**FRIENDS
OF THE
RIVER**

April 29, 2005

Re: Comments on Battle Creek Restoration Project SEIS/REIR

Inskip Reach, Battle Creek, Jun-Sep

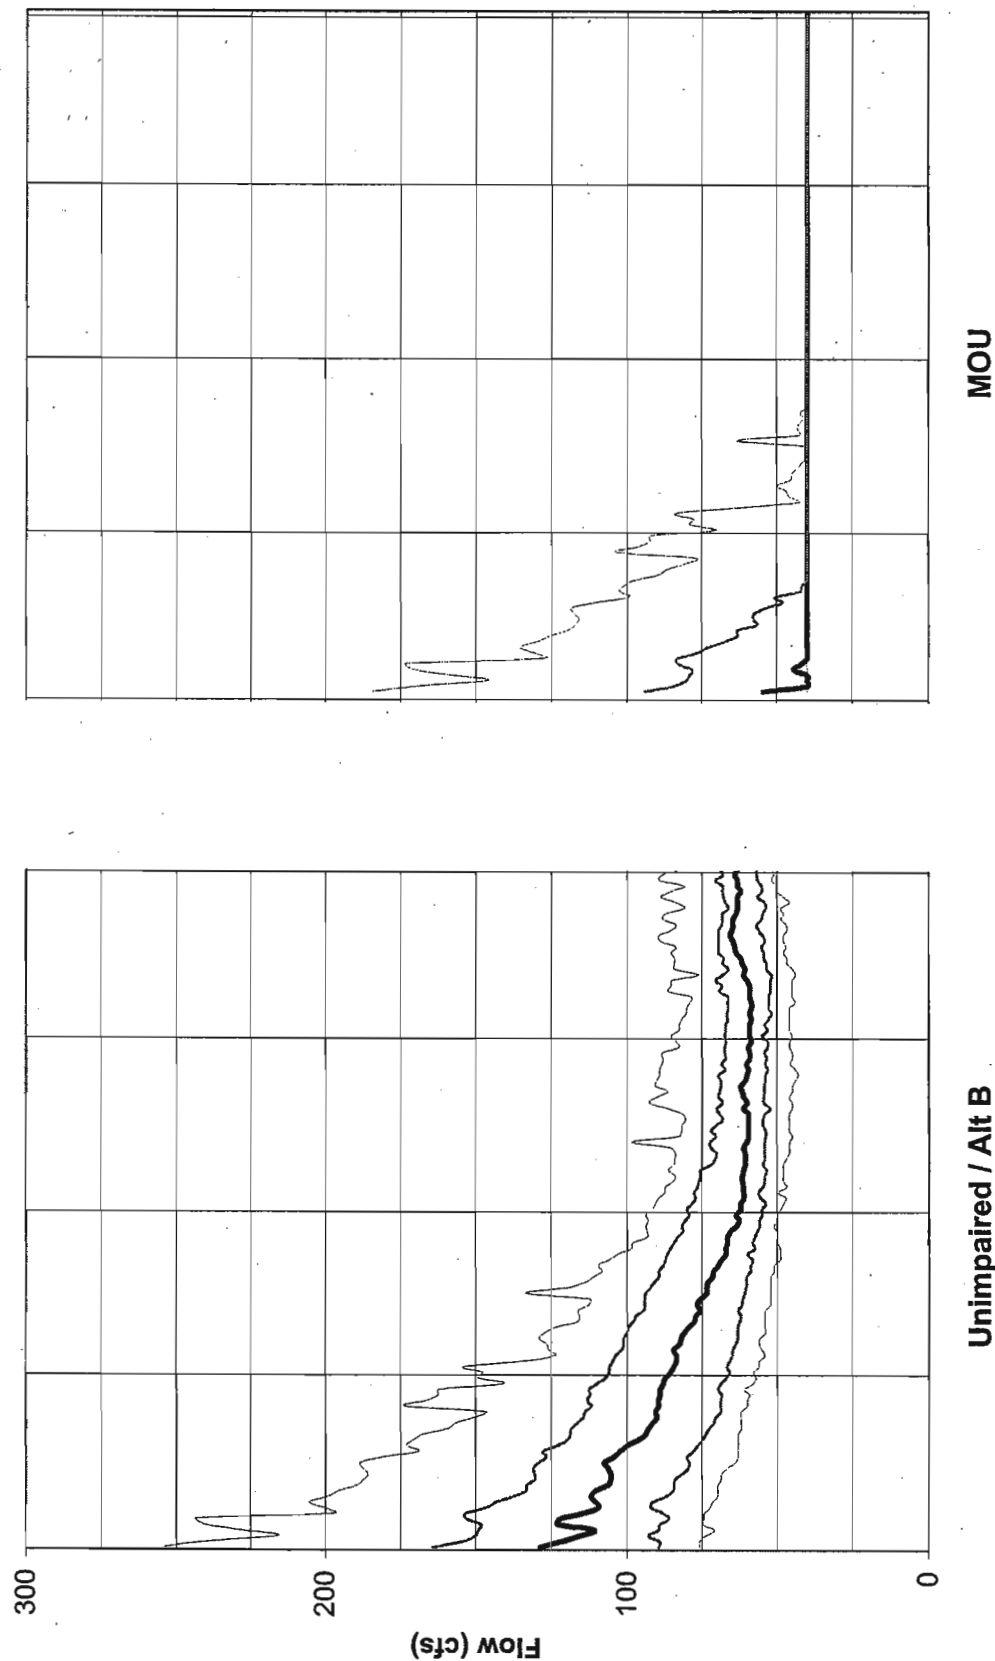
- **Magnitude.** Figures S-1 through S-6 compare unimpaired, MOU and Alt B synthetic water years using the 10th, 30th, 50th, 70th, and 90th percentile daily flows from the years 1962-2002 (1997 was excluded due to an incomplete record). While winter storm events are generally comparable for all alternatives, Alt B streamflows in spring, summer, and fall are significantly higher than MOU flows for all reaches and water year types: 50-55% more over the course of the year, and 80-130% more in summer. Unimpaired and Alt B flows show significant interannual changes in late summer/early fall low flow periods, whereas the MOU falls to the same, substantially lower flow for each reach and year type. Interannual baseflow variability under Alt B would cause physical habitat, temperature, and passage conditions to vary somewhat from year to year, allowing fish to exploit outstanding habitat conditions on a recurring basis.

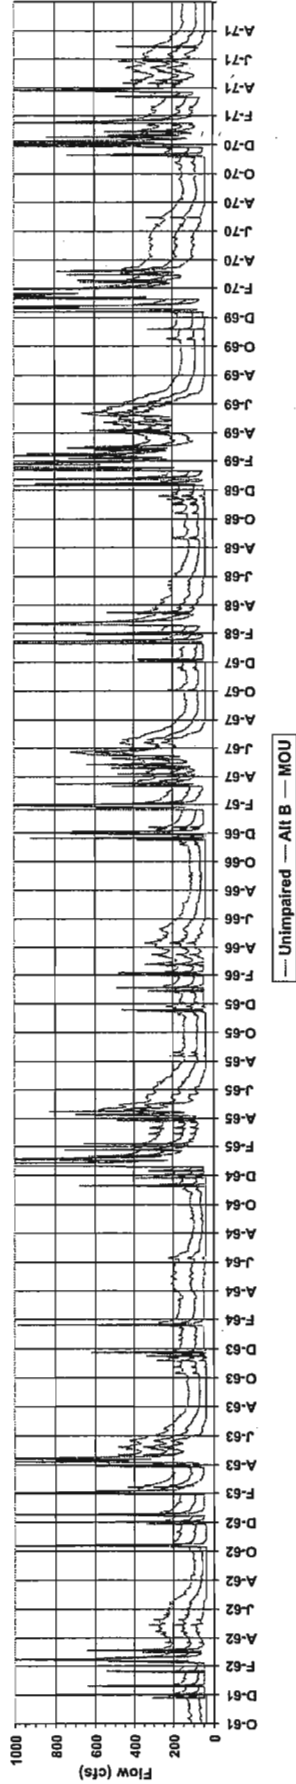
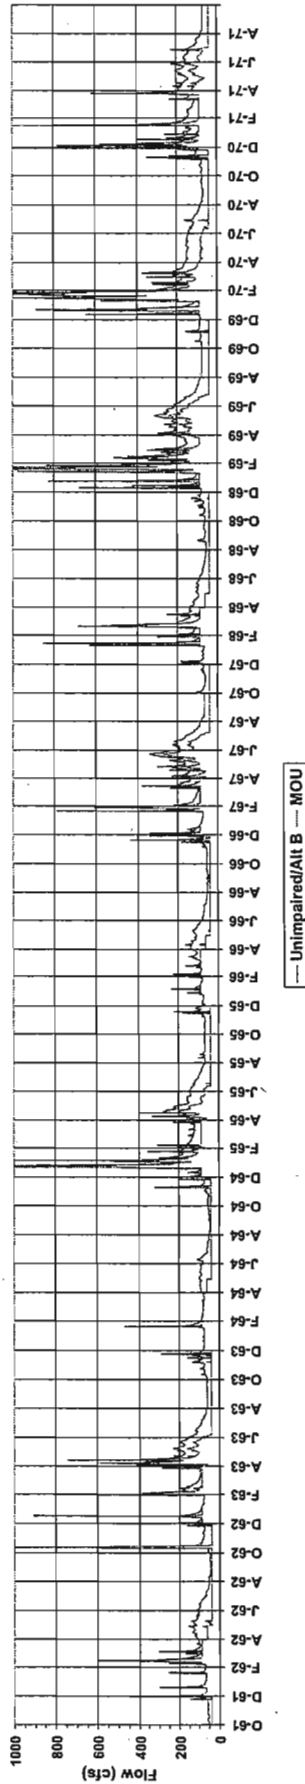
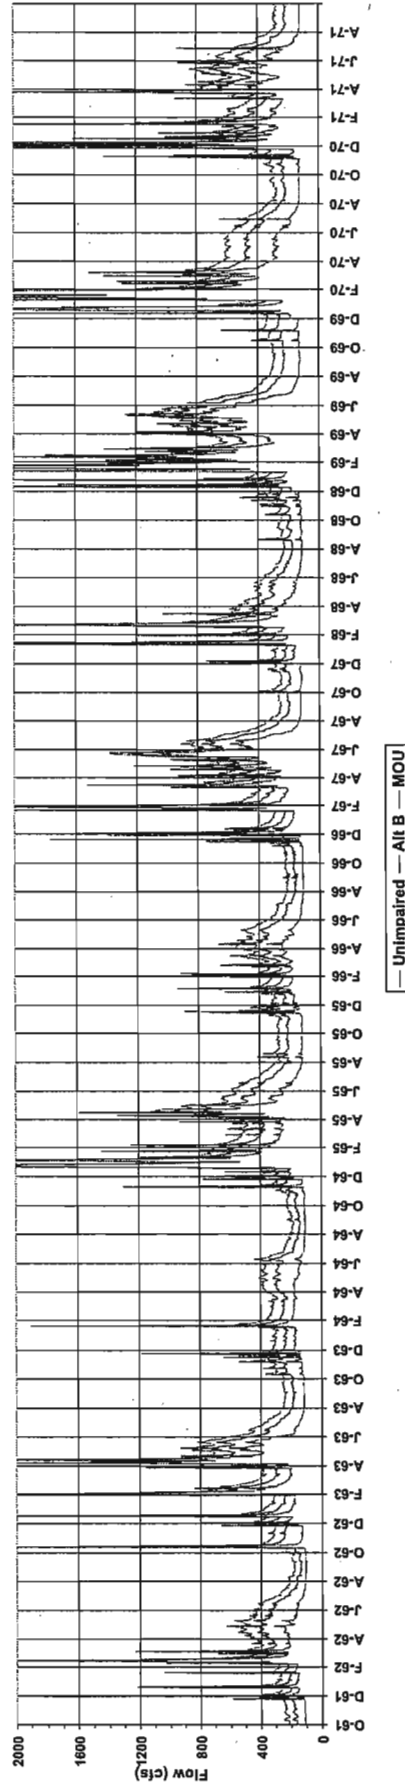
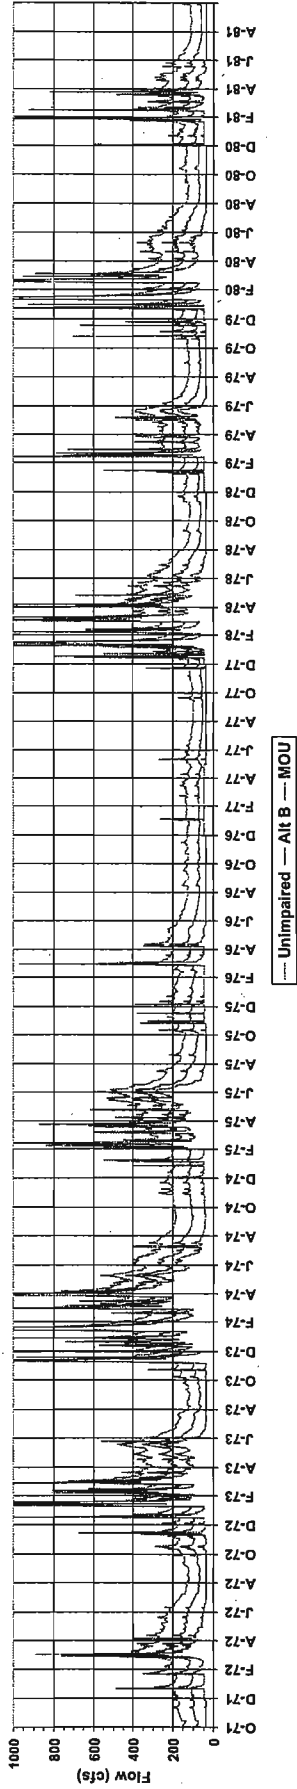
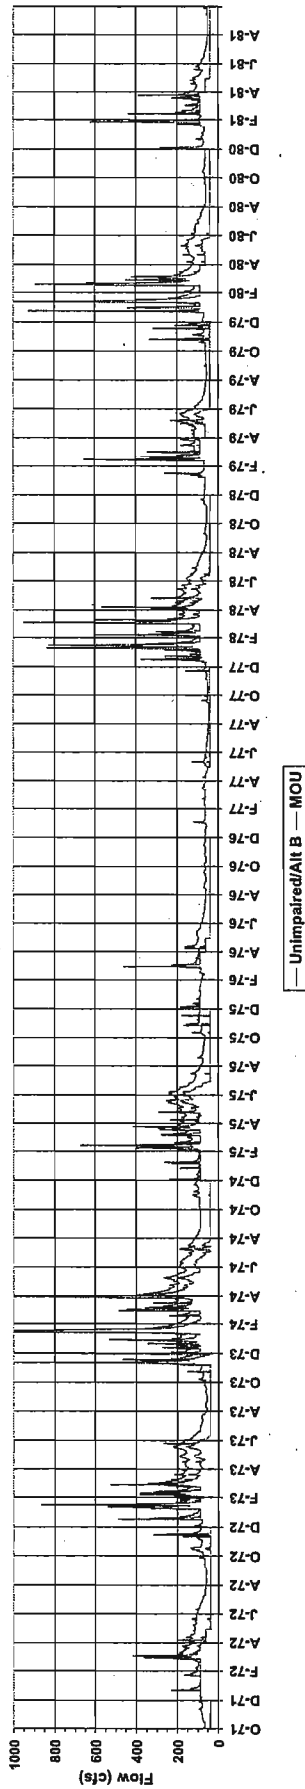
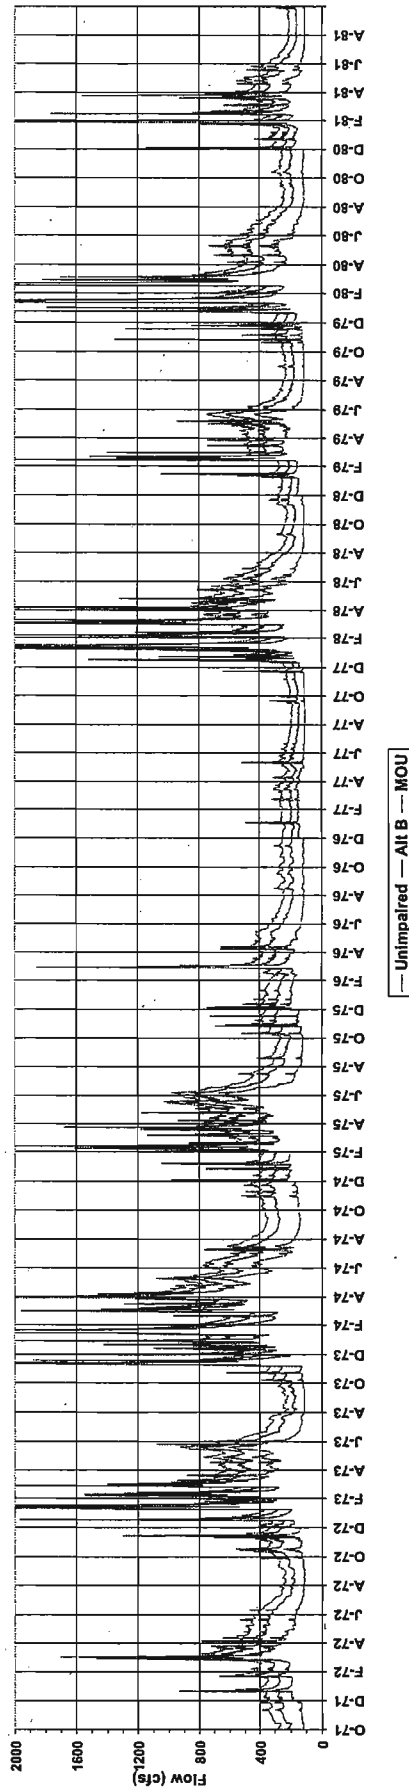
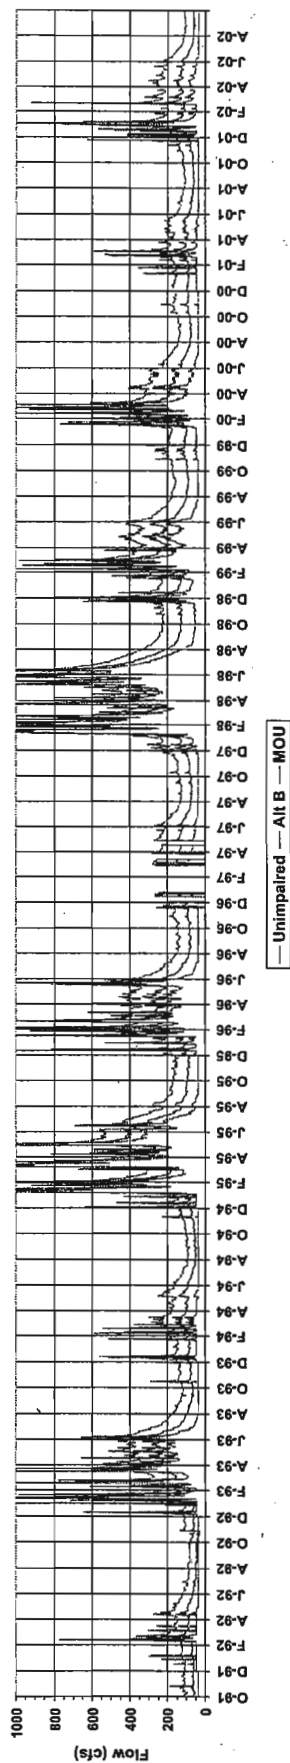
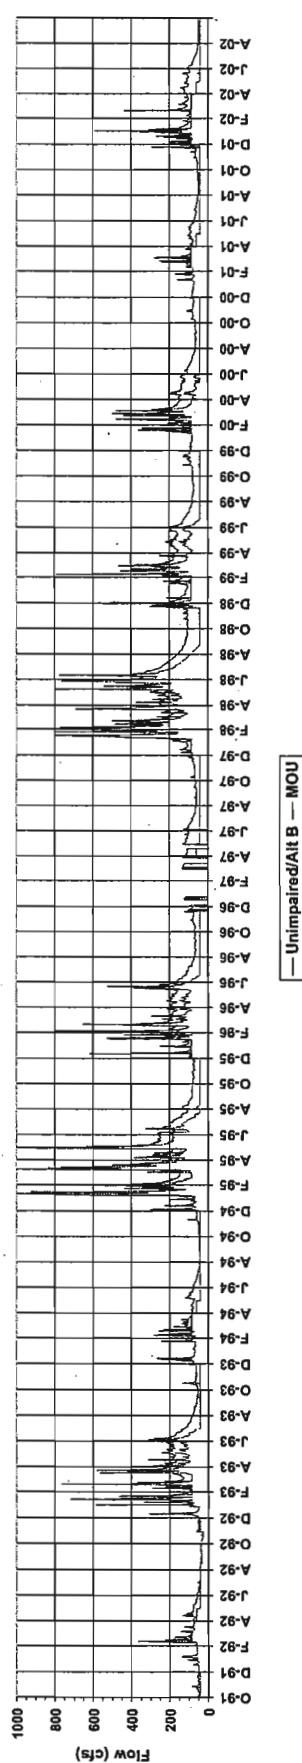
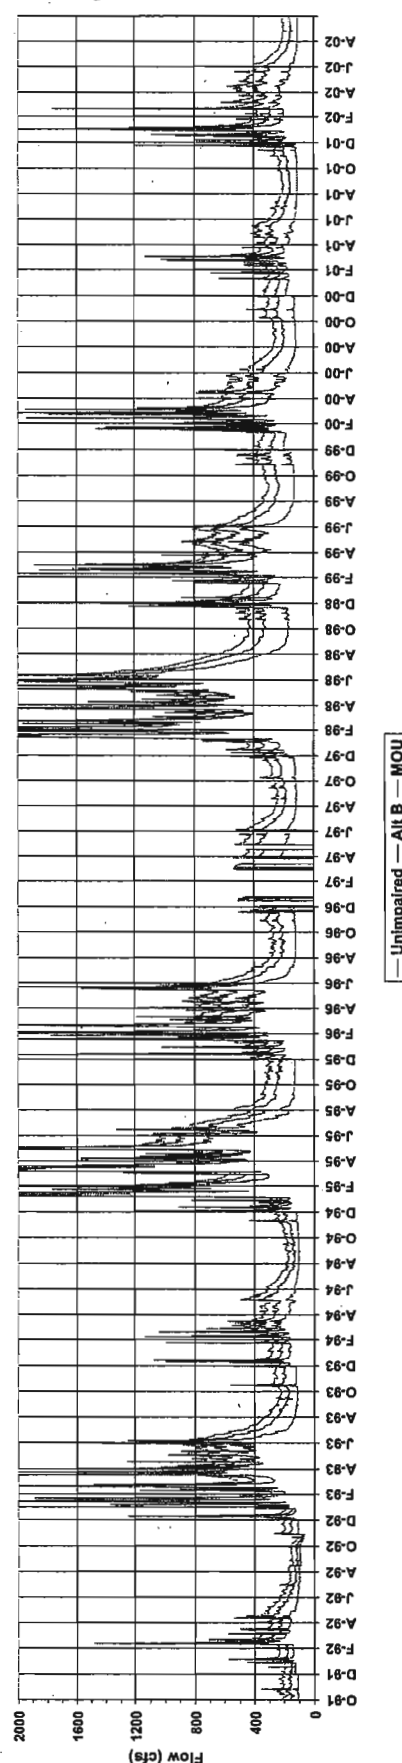
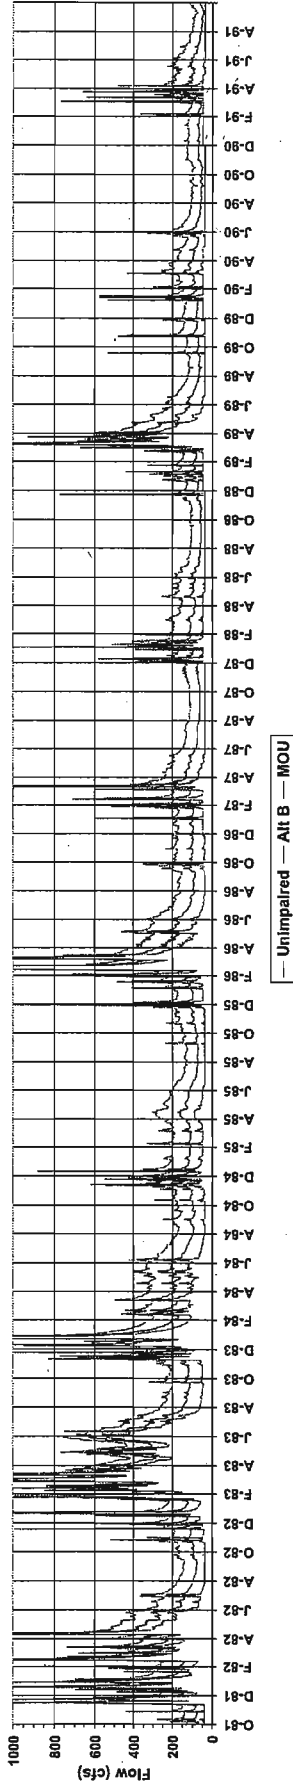
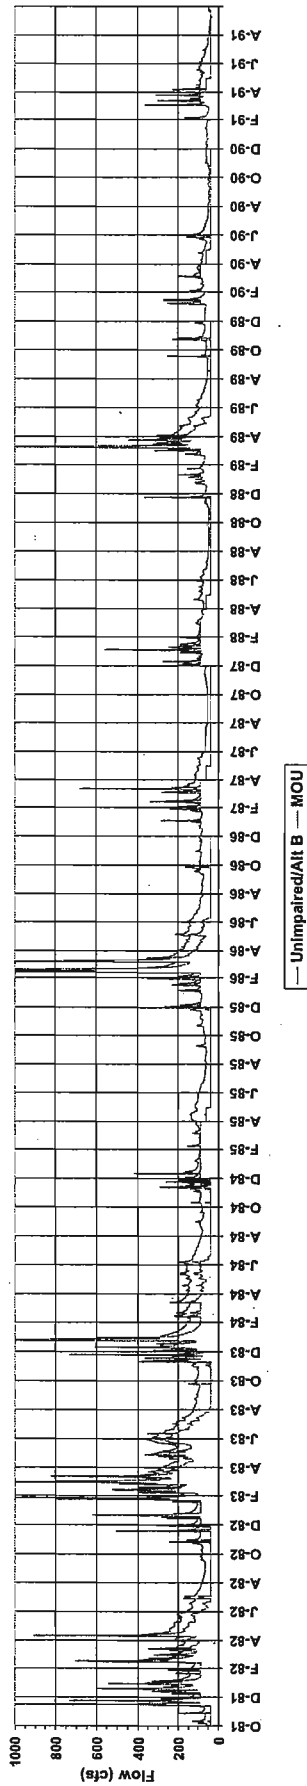
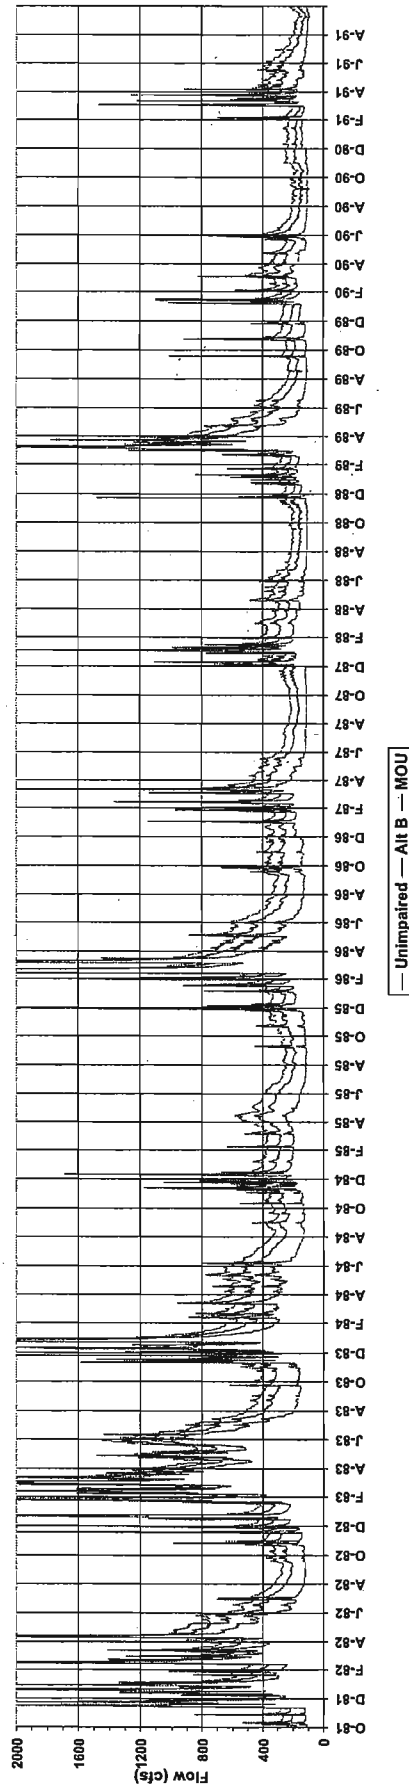
- **Frequency.** Comparative analysis of Figures H-1 to H-4 (hydrographs of water years 1962-2002) shows that low to mid level pulses are more frequent in the late fall and early spring under Alt B. The geomorphic discussion below outlines how Alt B may provide flows capable of mobilizing sediment more frequently than the MOU.

- **Rate of change.** At least three issues arise related to rate of change. First, smaller peak events have a much more abrupt interface with the baseflow under the MOU than under Alt B or unimpaired (Figures H-1 to H-4), possibly causing fish stranding. Second, under unimpaired and Alt B flow regimes, the transition from the winter (high) to summer (low) flow season is long and gradual. The onset of lower, stable baseflows under the MOU is much earlier, and more abrupt. Finally, on the South Fork, for most year types, the transition between the summer and winter flow releases below Inskip dam (40 and 86 cfs, respectively) does not occur at the more gradual rate seen under unimpaired and Alt B.
